SERVICE LETTER

SUBJECT: IPECO SERVICE BULLETIN 318-25-03

Ipeco Service Bulletin 318-25-03 Issue 2 - Change to Armrest Assembly

PILATUS PC-12

FIGURE 1
(Seat shown in Fully Down Position)

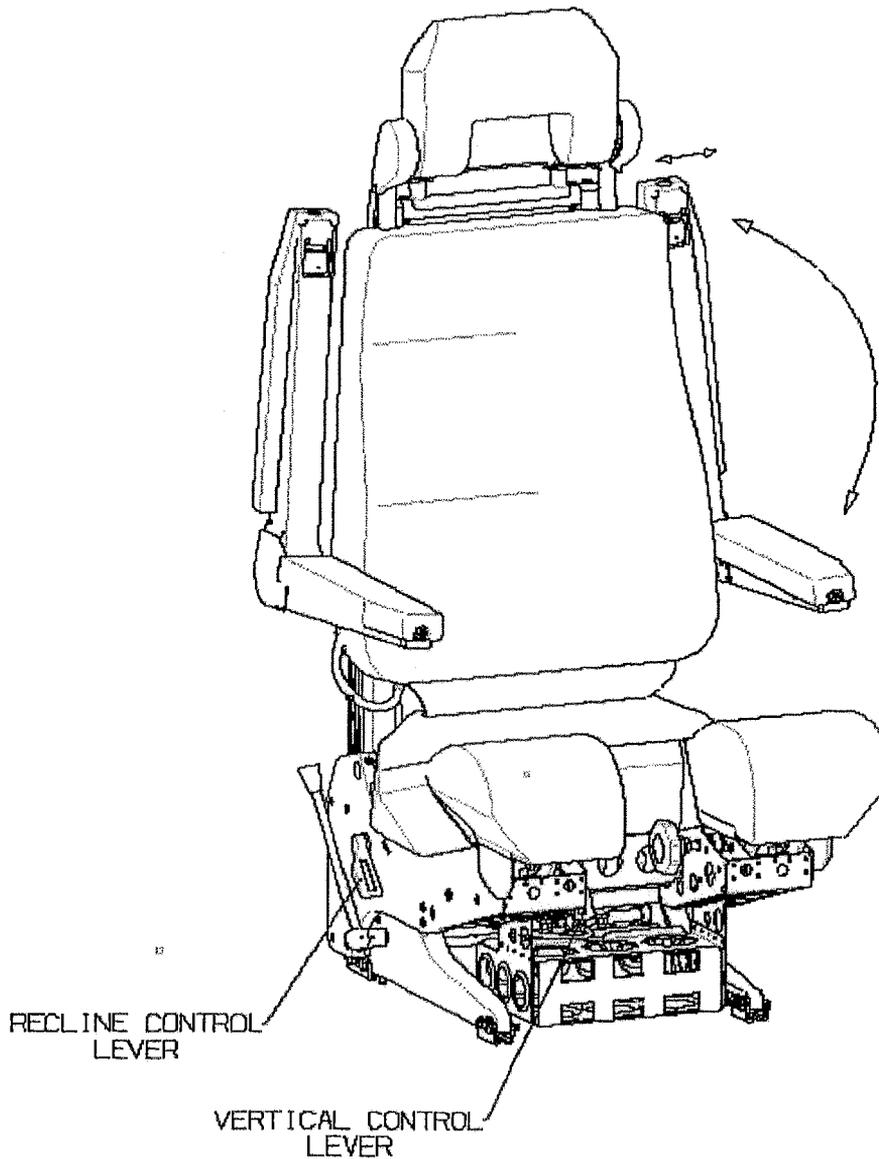
1. Remove seat from aircraft (refer to aircraft maintenance manual).
2. Operate the vertical handle and position seat in the fully up position. See figure 1.
3. Operate the recline control lever and adjust seat back to minimum recline position. See figure 1.
4. Rotate both armrests fully forward to deploy. See figure 1.
5. Remove and retain the csk hd screw (1-14) and associated cup washers (1-15) (Inboard Armrest only). See figure 2.
6. Remove and retain the armrest upholstery (1-6, 1-10) and armrest cover (1-7, 1-11). (Inboard Armrest only). See figure 2.
7. Remove and retain the special bolt (1-18). (Inboard Armrest only). See figure 3.
8. Remove and discard the four csk hd screws (1-39) and associated cup washers (1-42). See figure 2.
9. Remove and retain the armrest structure cover (1-36, 1-33). (Inboard Armrest only) See figure 3.

FIGURE 4
(Outboard Armrest only, Rest of seat not shown for clarity)

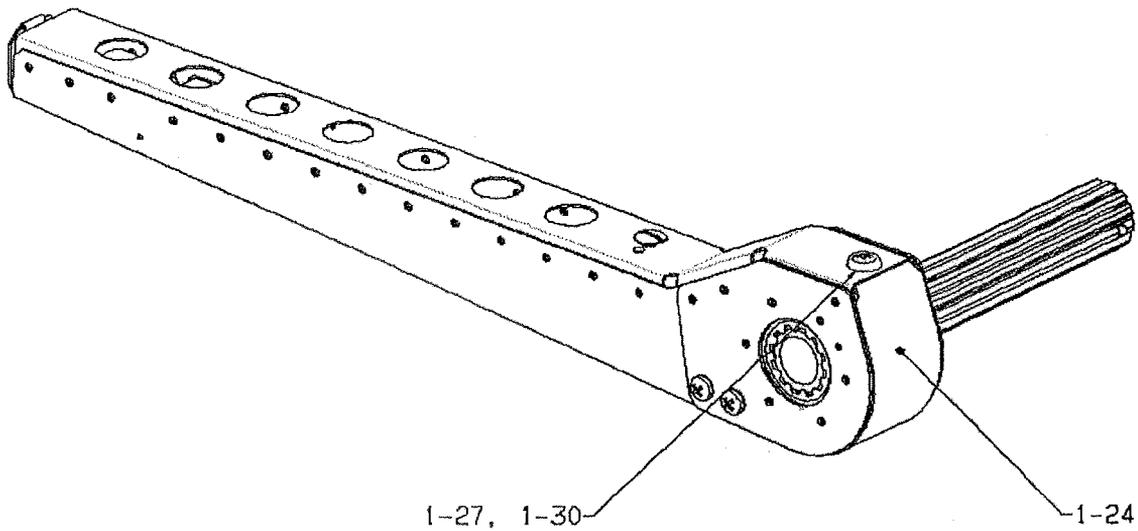
10. Remove and retain the csk hd screw (1-27) and associated cup washers (1-30) (Outboard Armrest only). See figure 4.
11. Remove and retain the armrest rear cover (1-24). (Outboard Armrest only). See figure 4.

FIGURE 5
(Rest of seat not shown for clarity)

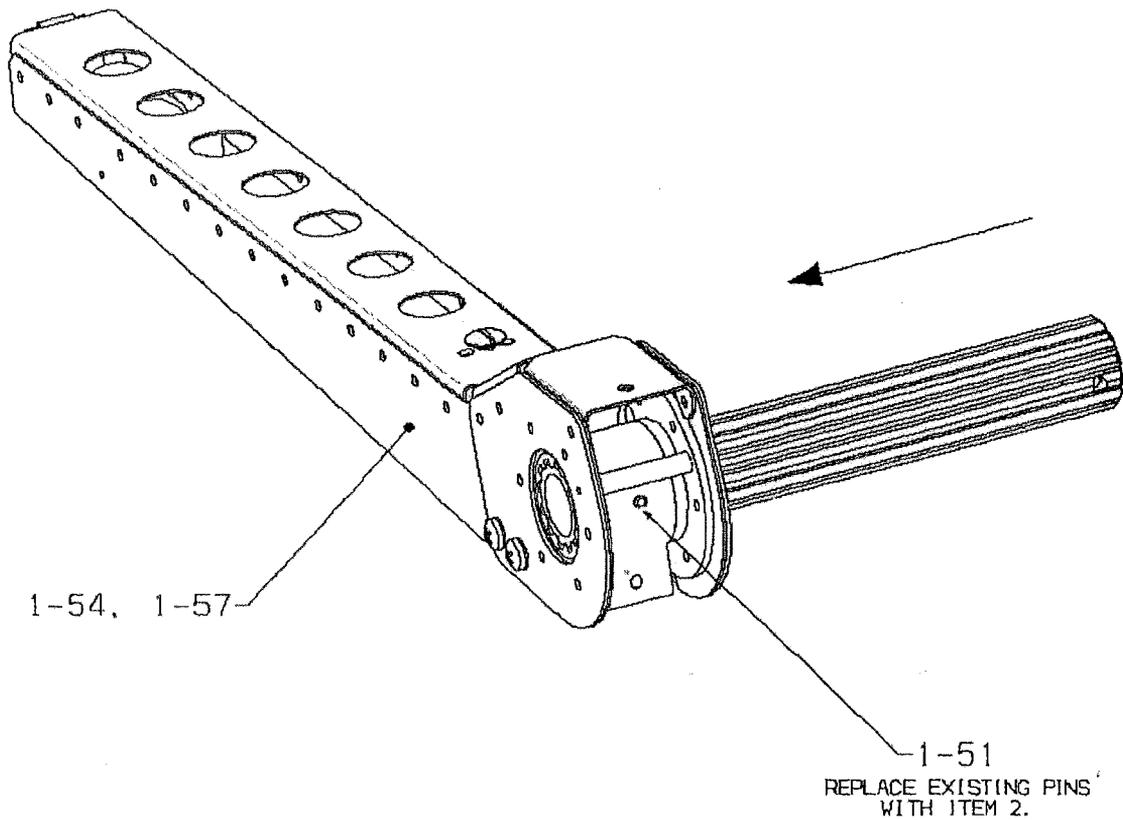
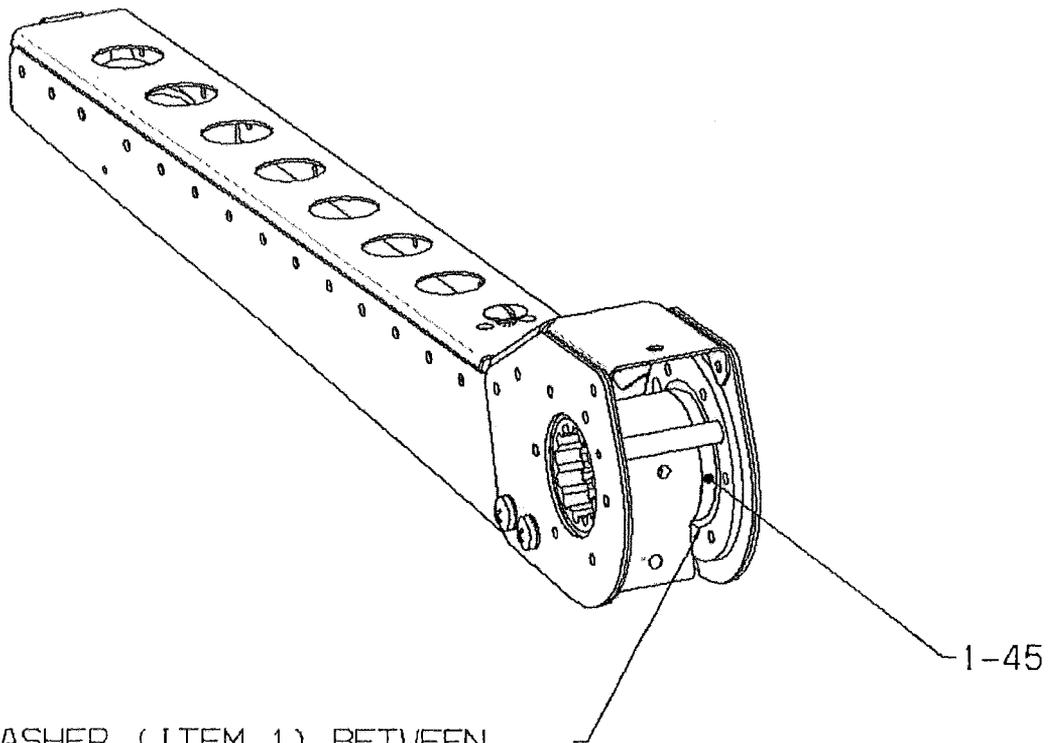
12. Drive out and discard the two spirol pins (1-51) during reassembly replace with new spirol pins (Item 2, table 1). See figure 5.
13. Remove the armrest assy (1-54, 1-57) taking care not to damage the paint work.

15. Reassemble in reverse order noting to replace the two spirol pins (1-51) with new spirol pins (Item 2, table 1). See figure 5. Add four pan hd screws (Item 3, table 1) instead of the four csk hd screws (1-39) and associated cup washers (1-42). See figure 7.
